**THE CAMBOURNE TO CAMBRIDGE ORDER**

**REBUTTALS - APPENDICES**

# **Cambourne to Cambridge (CtoC) Scheme**

Further Assessment of CPPF Alternative Scheme

| SCALE @ A1: | 1:100 @ A1 | CHECKED: | BN | APPROVED: | GH |

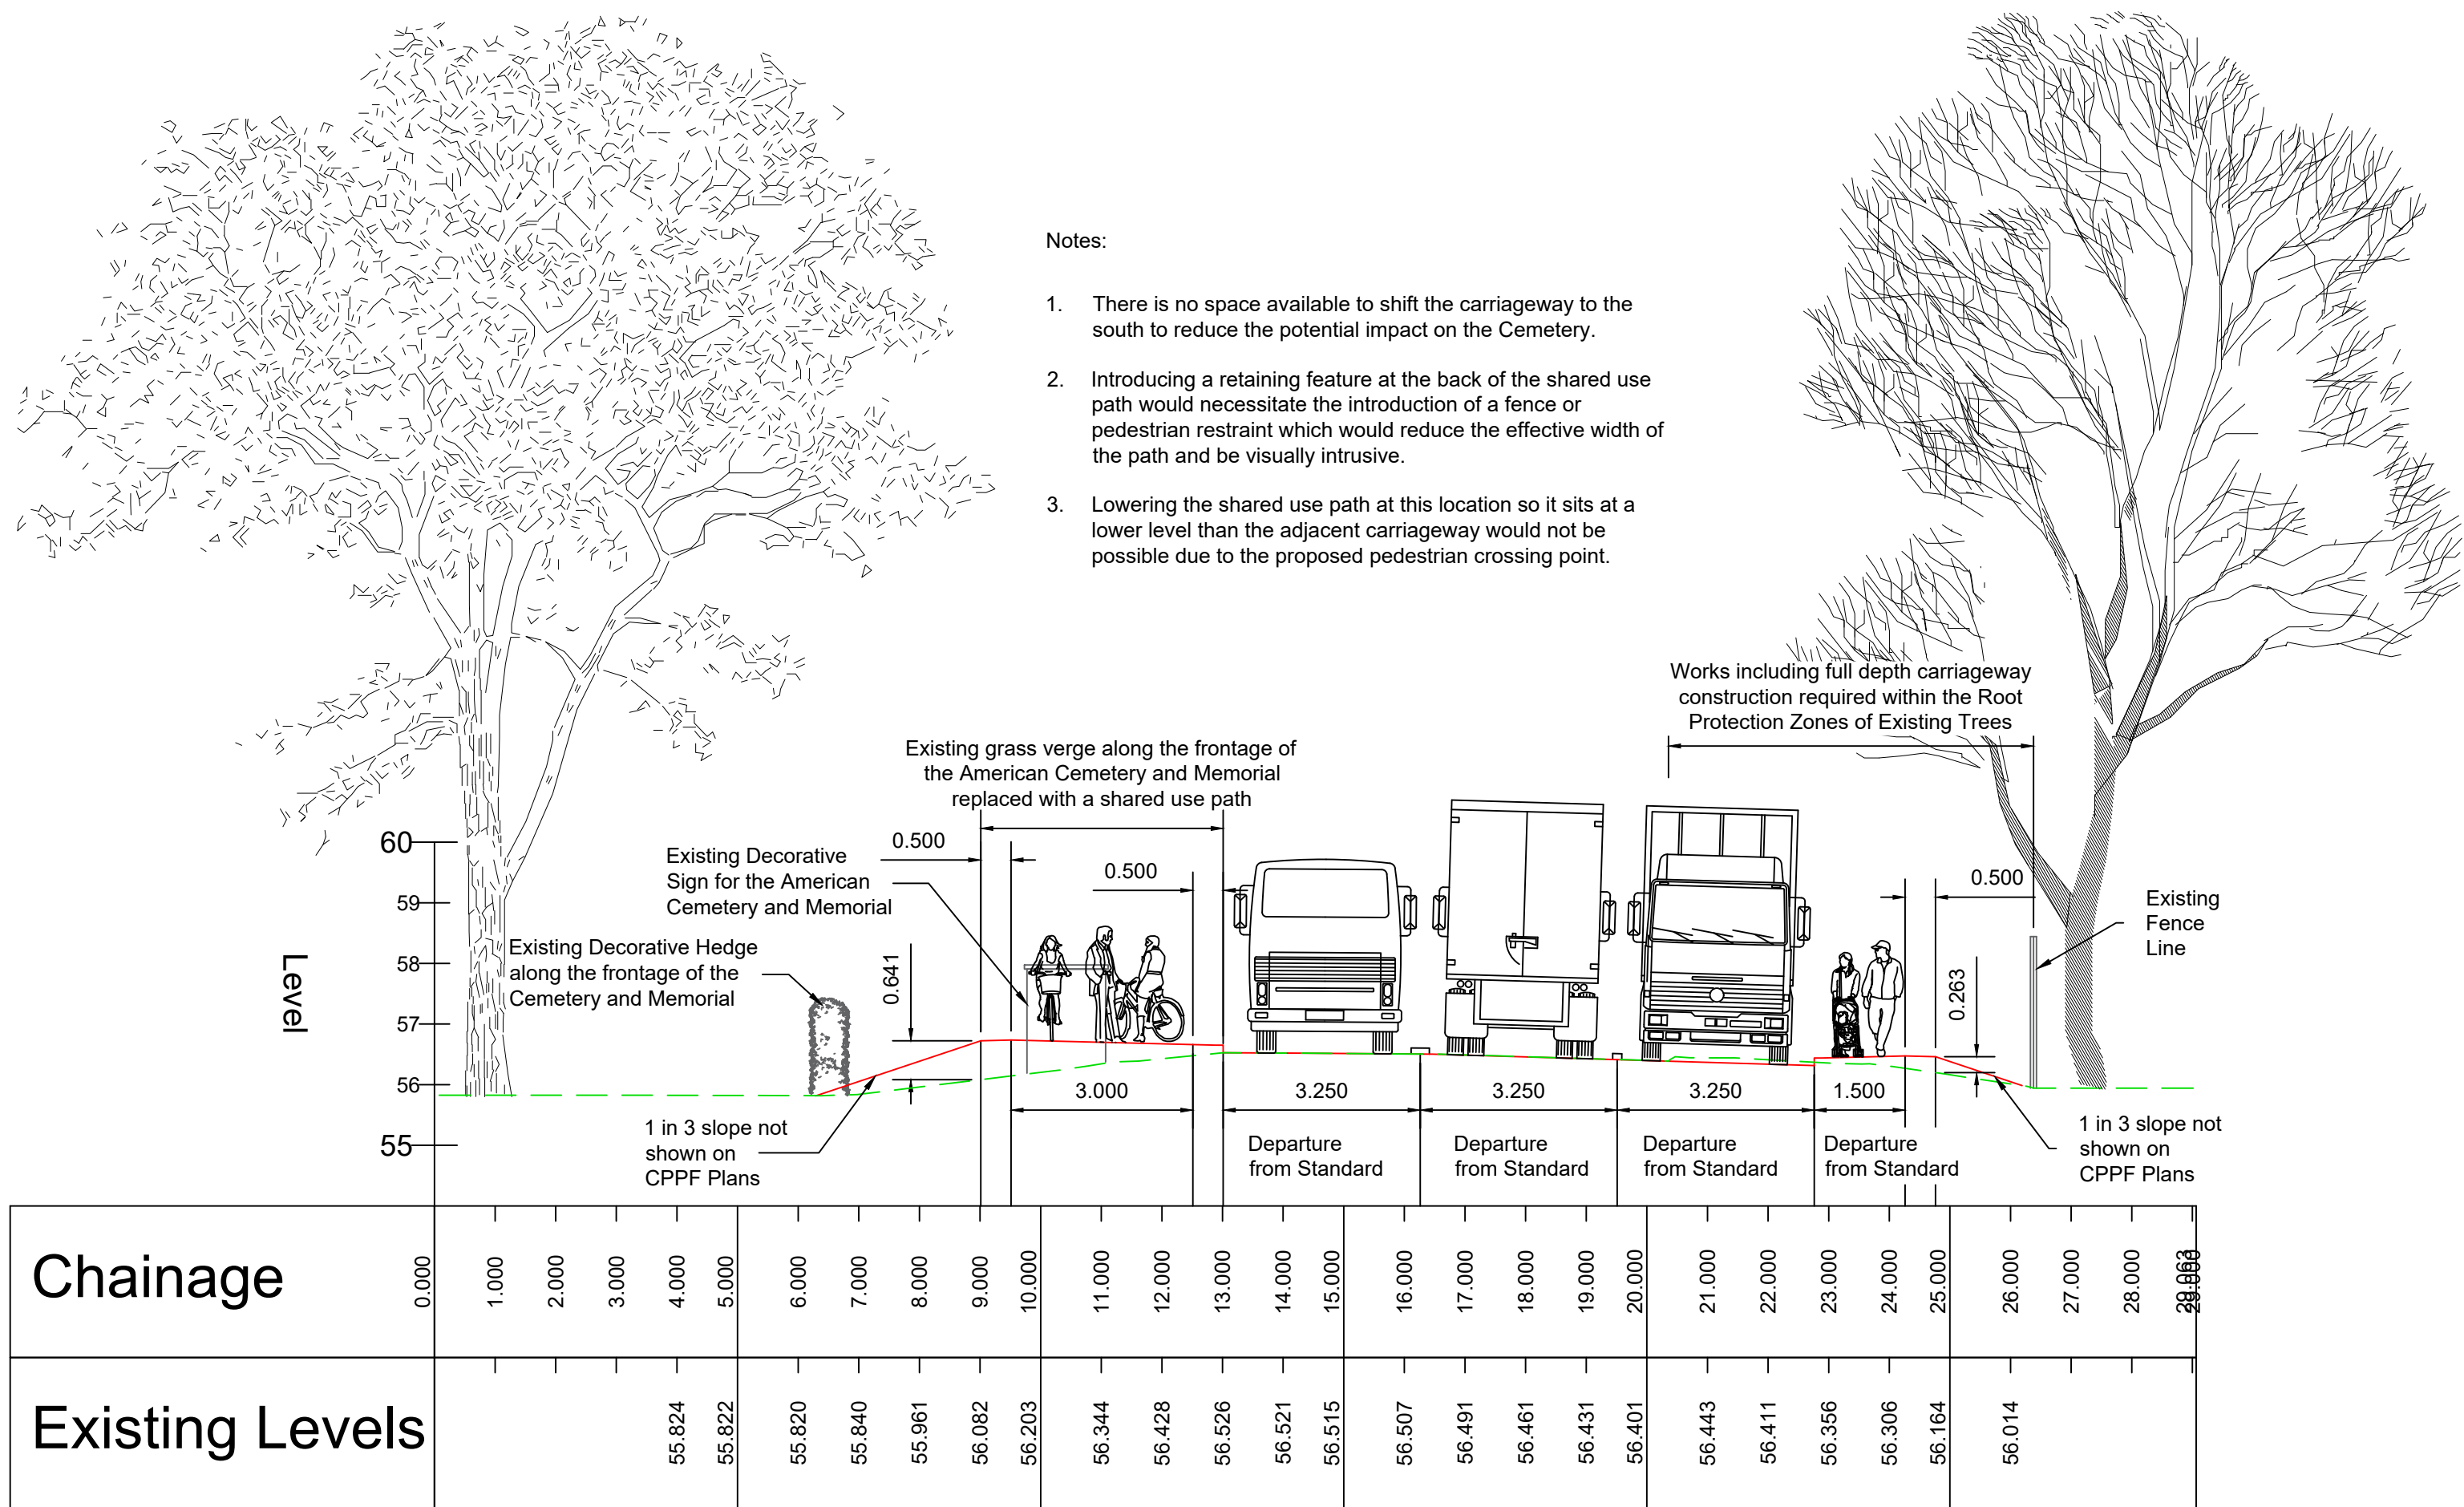
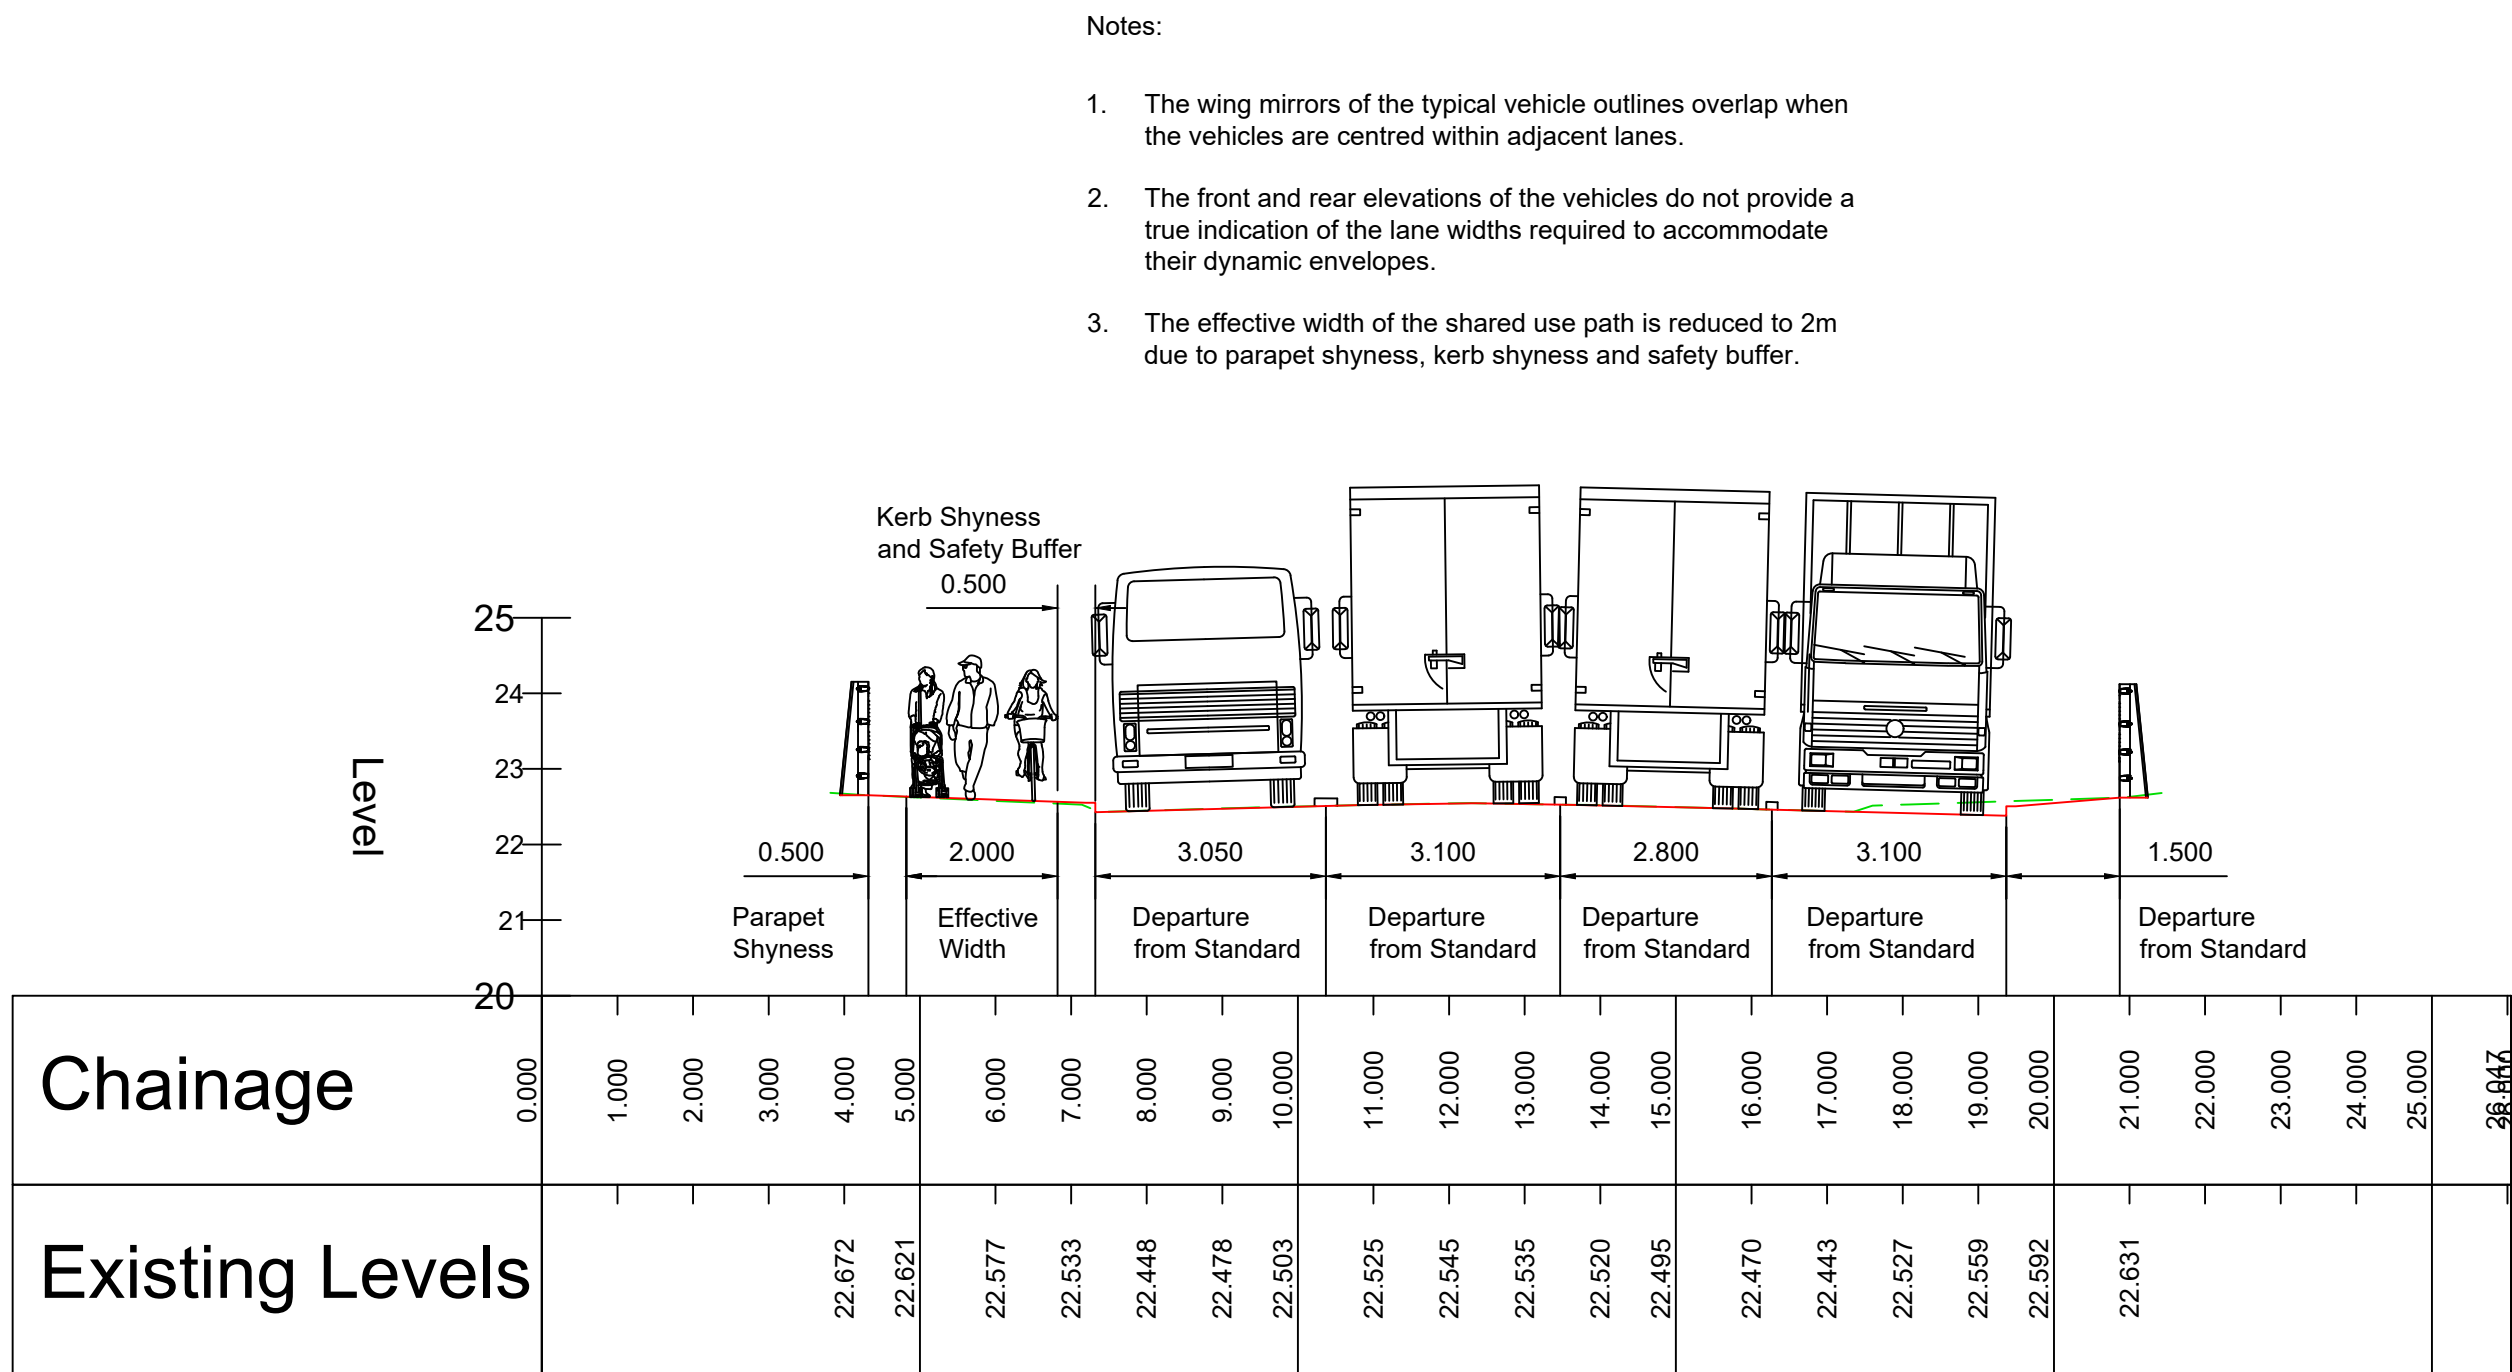
- Cross sections are based on the CPPF Proposed Scheme Layout (Civilistic Drawings C-001, C-002, C-003).
  - A 0.5m verge/berm has been added to the cross sections (not shown on CPPF drawings) to:

- Provide a safety buffer between the path edge and any slopes, helping maintain effective path width near vertical features.
  - Where level differences exist, a 1:3 slope has been included to tie into existing ground levels.
